CHABOT-LAS POSITAS COMMUNITY COLLEGE DISTRICT PURCHASING DEPARTMENT

Addendum No. 2

REQUEST FOR PROPOSAL BID: B23/24-05 Pool Resurfacing Project at Las Positas College

DP-1

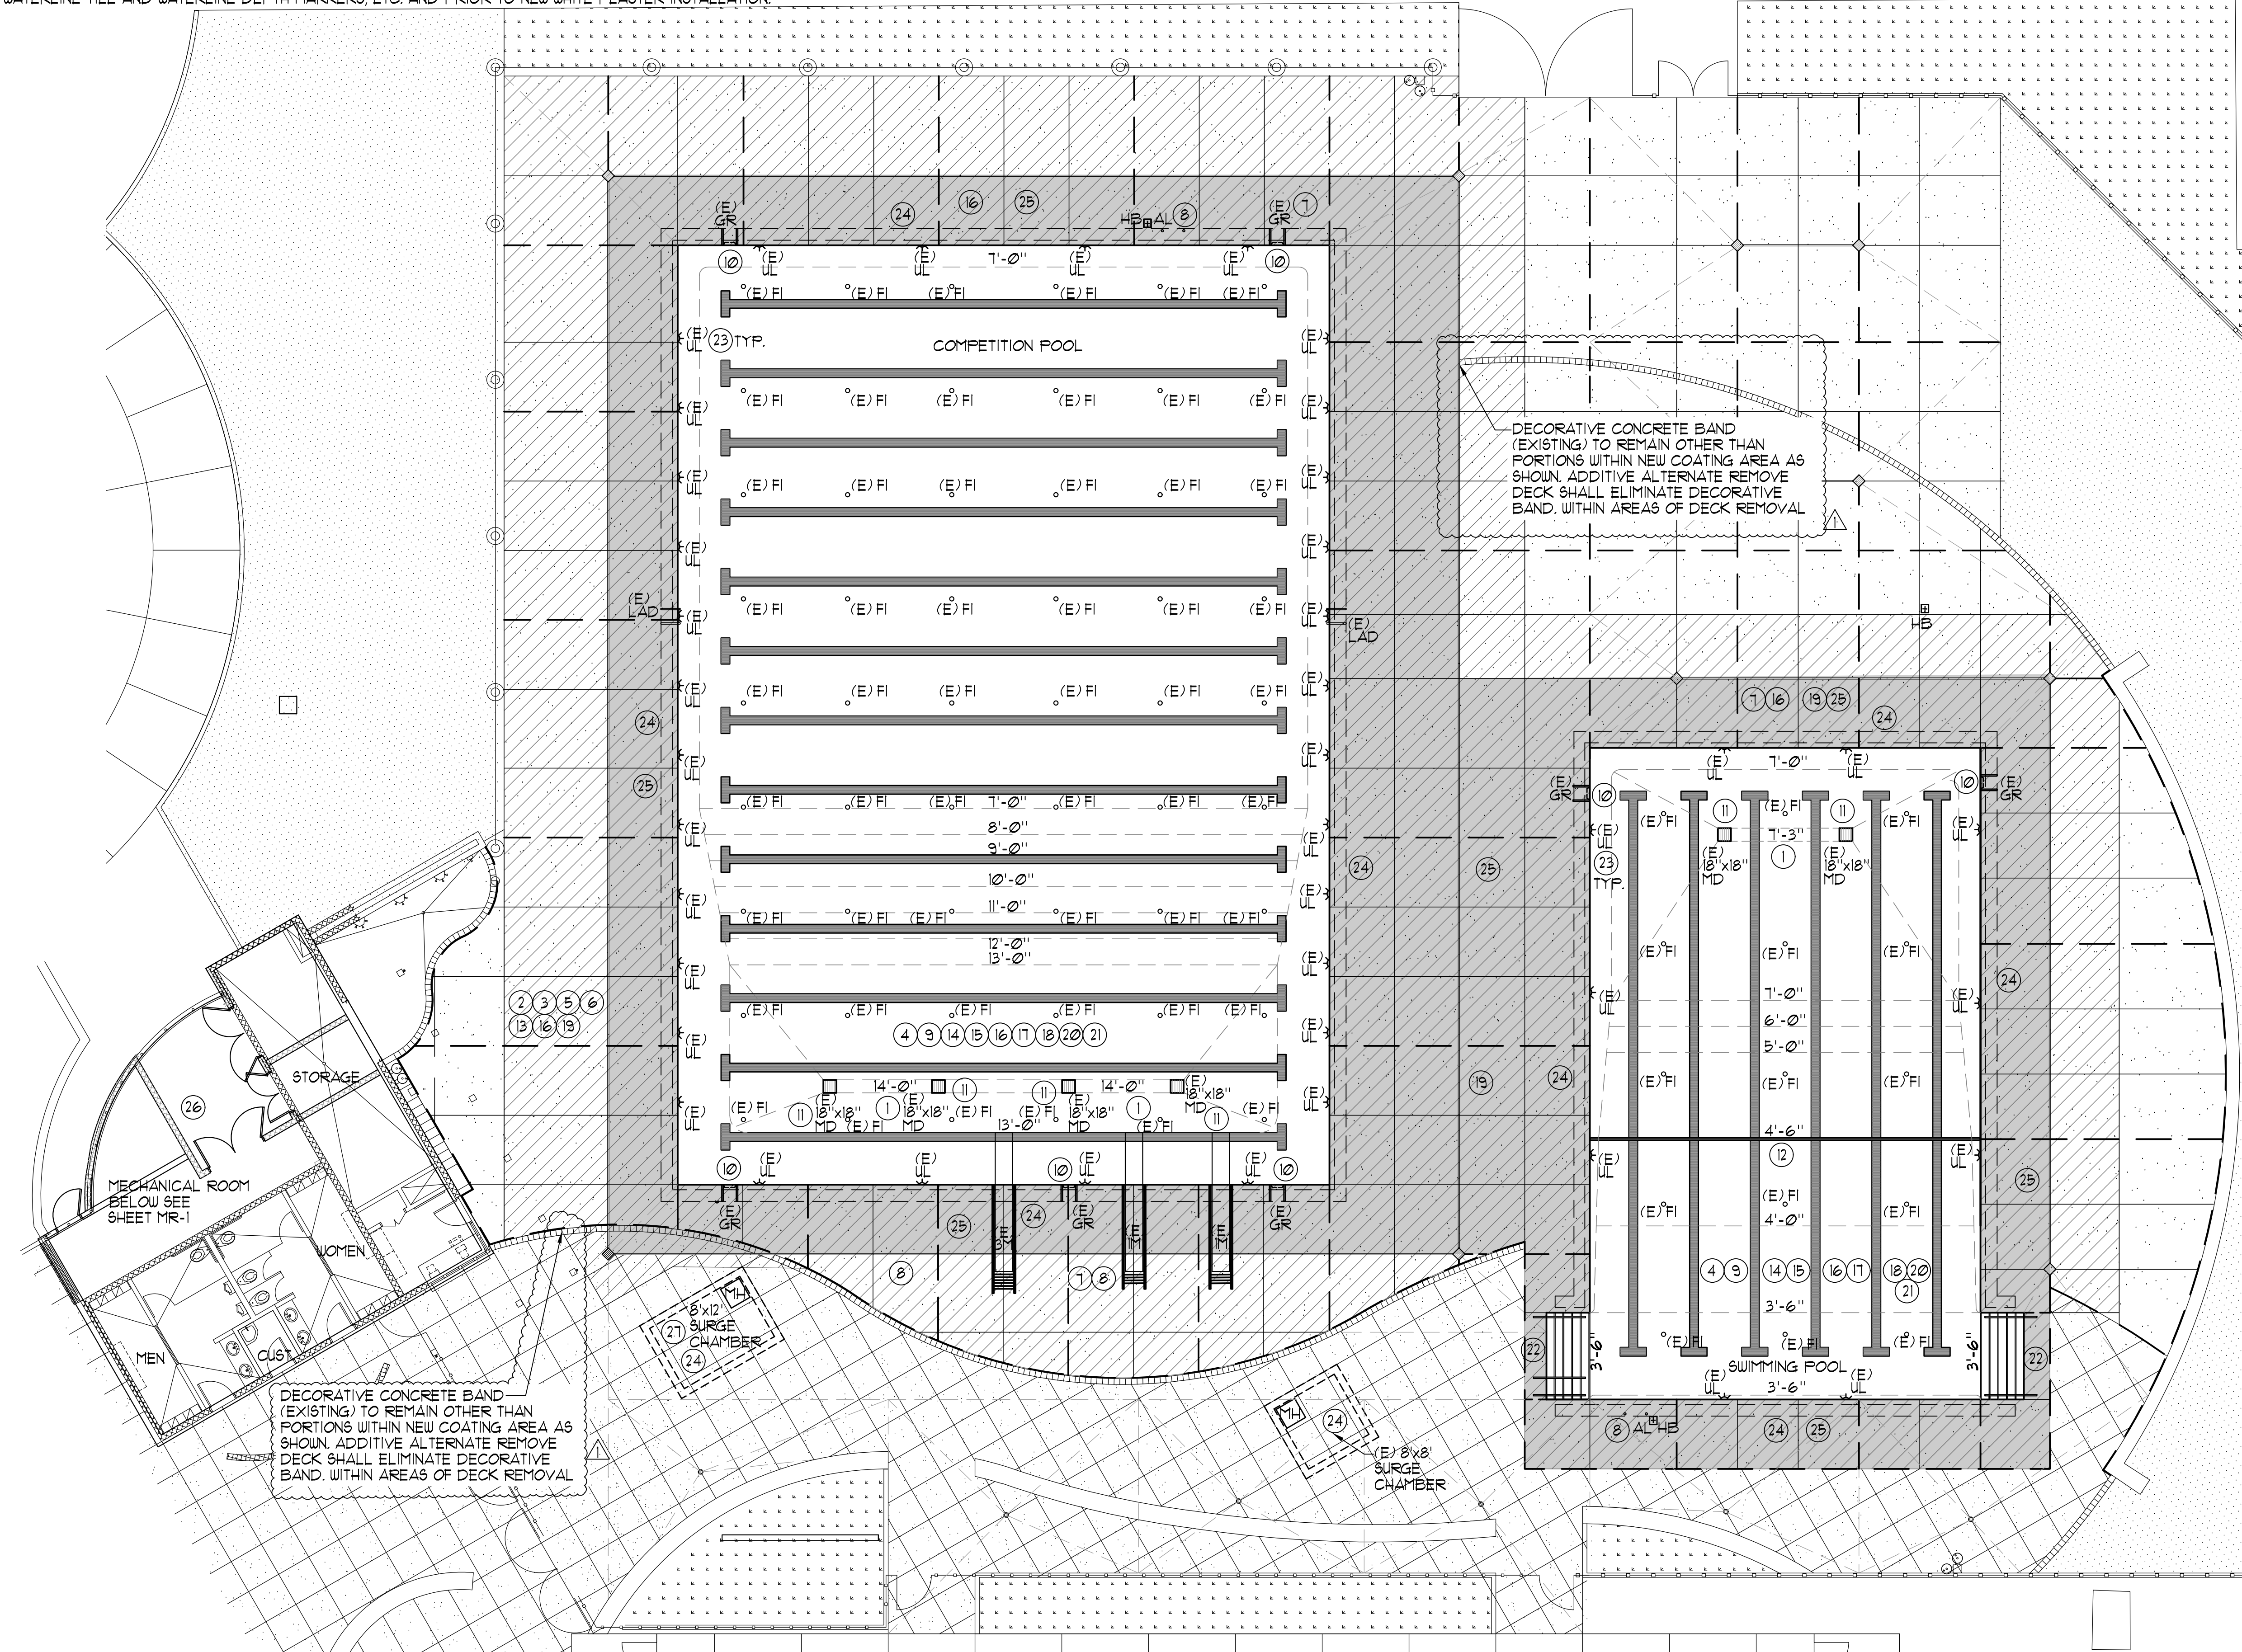
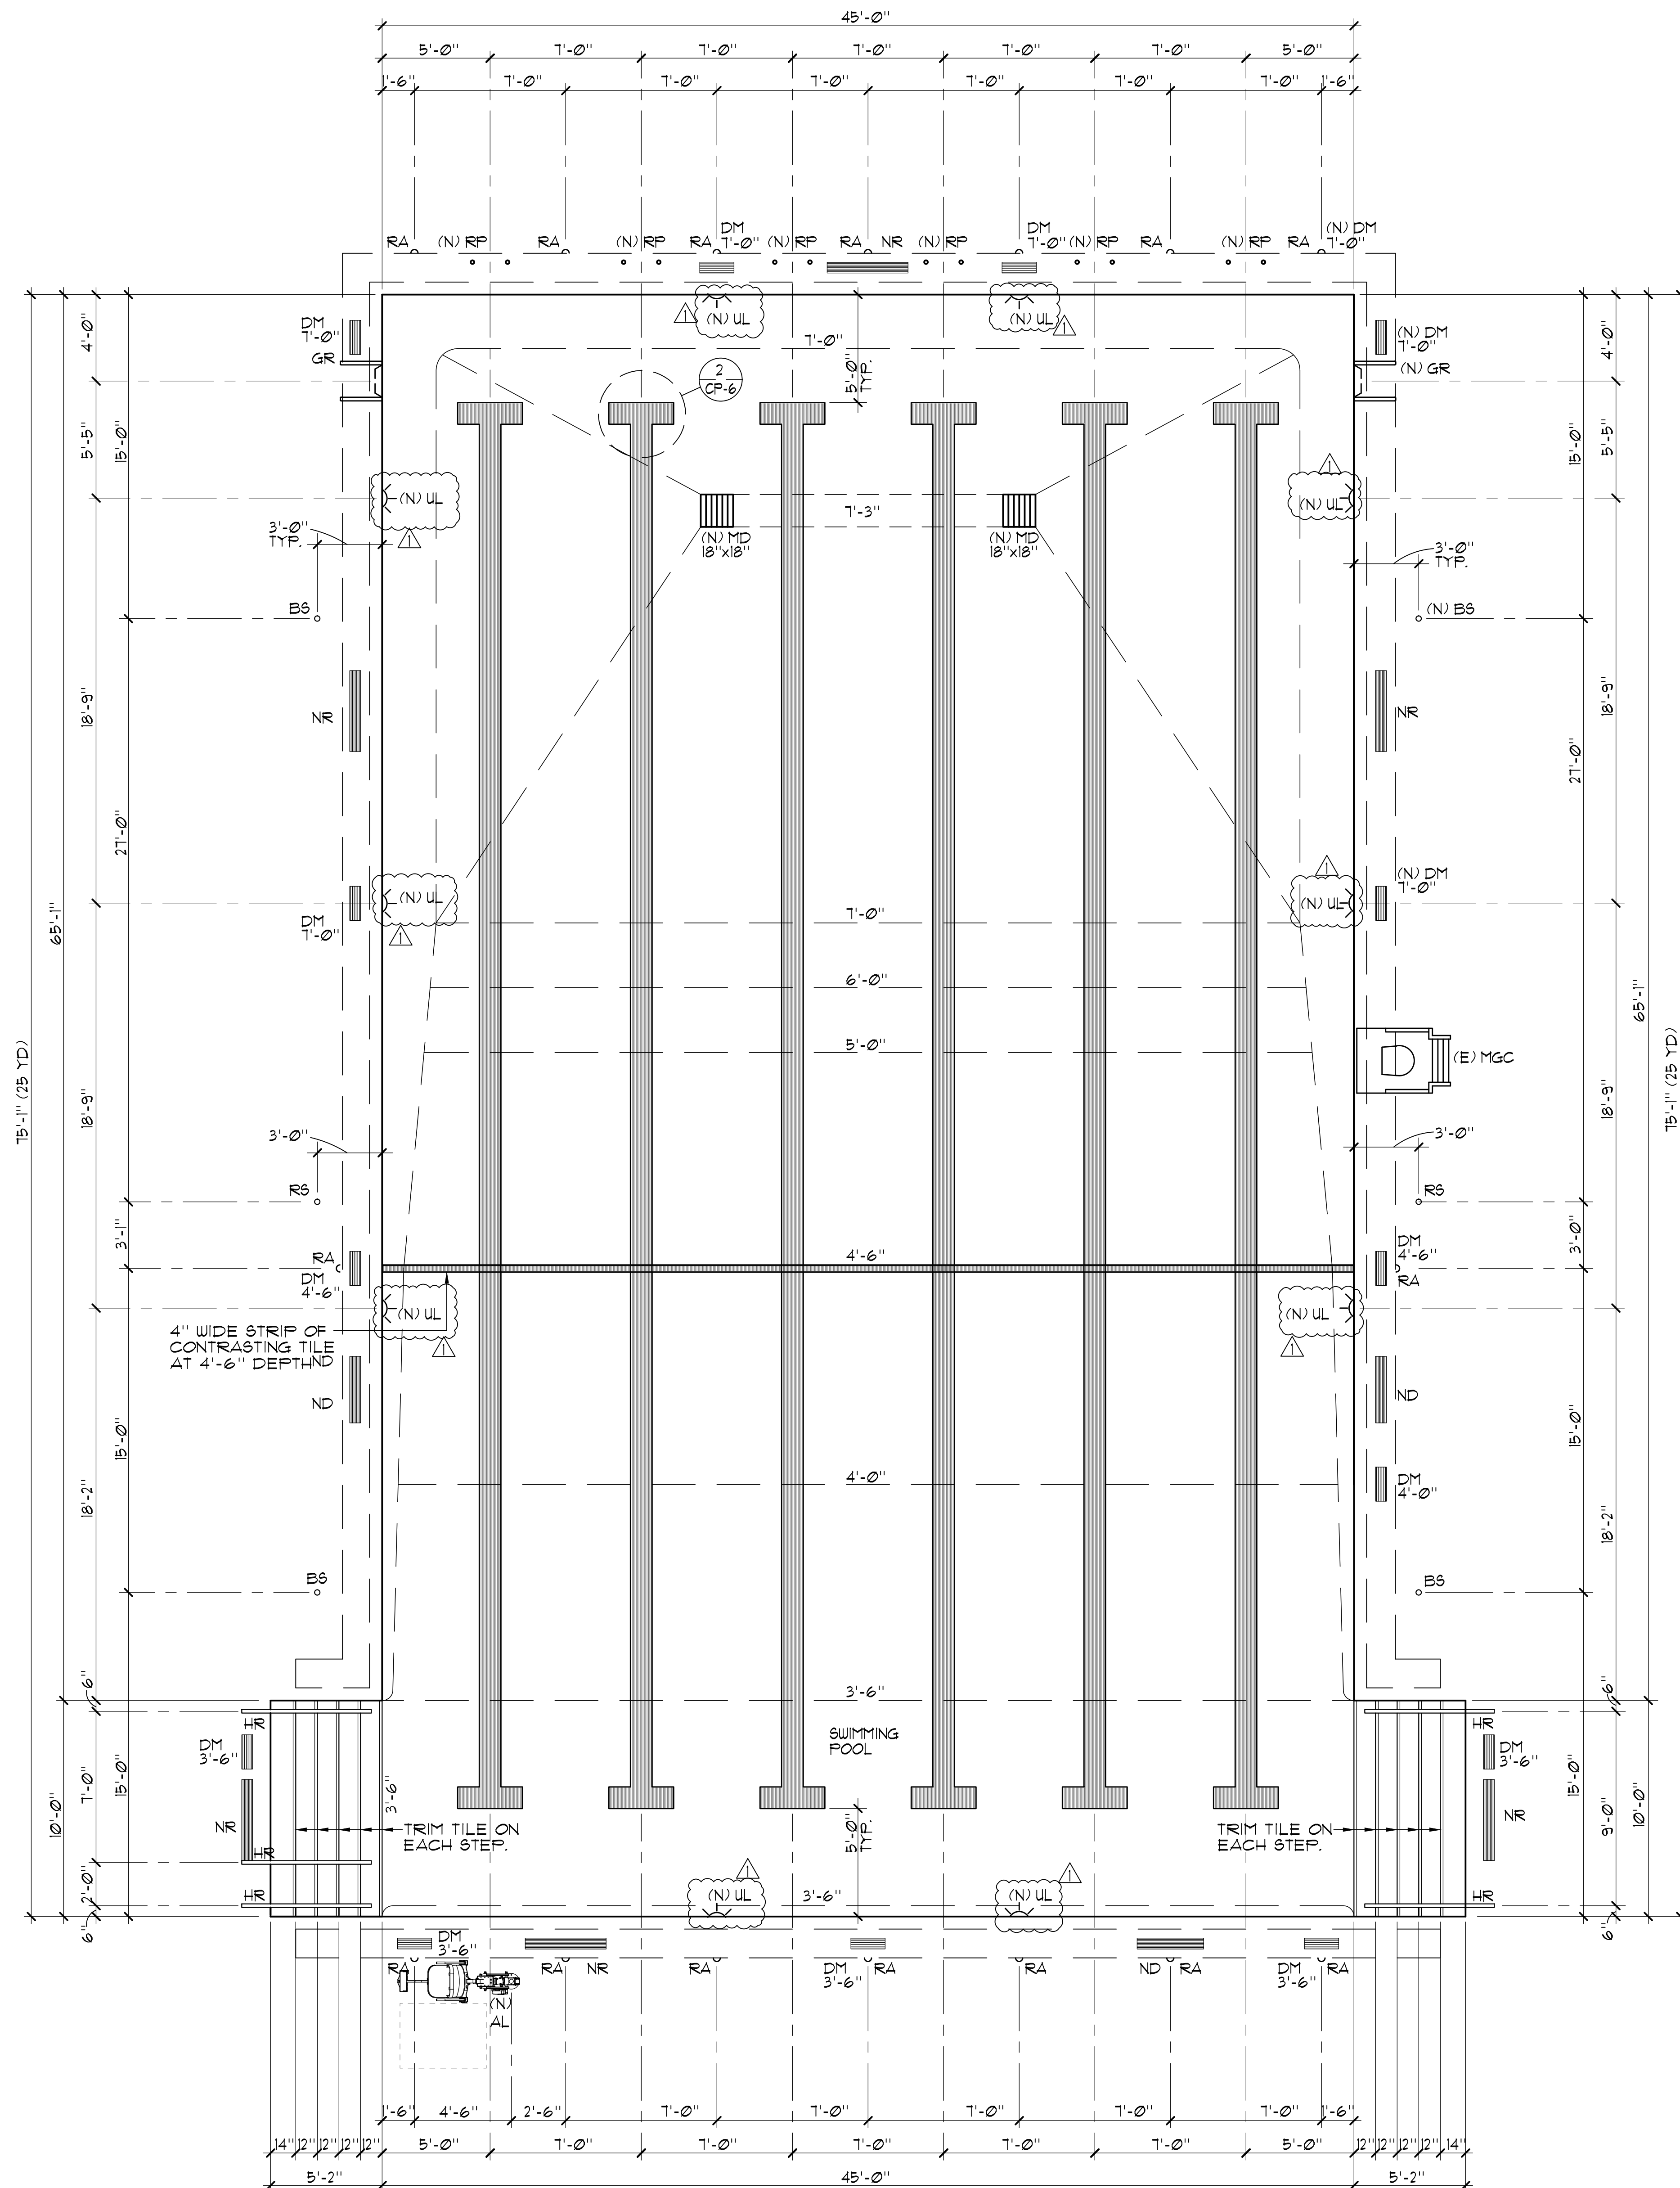
1. **Sheet DP-1 Demolition Plan:** Clarification on keynote #20, removed reference to sheets SP-1 and CP-1.
2. **Sheet DP-1 Demolition Plan:** Clarification on keynote #1, contractor responsible for pool drain down.

Question No. 1: When you download plan set from the Las Positas College website; Plan Sheet DP-1 has yellow comment bubbles that cannot be removed from the plan sheet. Appears to be a formatting error.

Question No. 5: Refer to note #24 on plan Sheet DP-1, please provide existing pipe sizes & specifications for “valving and float valves” to be removed & replaced inside both surge chambers (tanks). During the job walk, these sizes could not be identified due to water in the tank.

Question No. 6: Please reference sheet DP-1 & photo below. There is a decorative concrete strip/band of what appears to be a pebble finish that may be impacted on both the pool (base bid) deck coating and/or the pool deck demo and replacement scope of work (add alternate). For the base bid scope of work, is the contractor to install Ardex coating over decorative concrete band areas shown in dark shade? For Add Alternate scope, is the contractor to remove and replace this decorative concrete band in like kind (where shown as hatched on DP-1), or remove and replace with standard concrete deck surface finish per new deck detail?

Question No. 8: Per note #9 on DP-1 and detail #3 on DP-8, contractor is to include all crack and rust repair to existing pool shell. Because pool shell cracks and rust may be under existing plaster/tile surface (not currently visible), the amount of crack and rust repair is unquantifiable. Please provide an estimated square footage or lineal footage of rust/crack repair that the contractor shall include in base bid. Or provide allowance for pool shell cracks and rust repair to be included on the bid form. Also, provide detail for pool shell rust repair.

Response: - See attached revised sheet with DP-1 with comment bubbles removed.

Response: ADG Response: Competition Pool – 12” EPD #2-0080-OH; Swimming Pool – 6” EPD #2-0080-OH; the pipe to be field verified by contractor.

Response: ADG Response: The deck repairs will eliminate the decorative band. See notes on sheet DP-1 detail #1 for clarifications regarding the decorative band.

Response: ADG Response: Assume 10 feet of crack repair in bid.
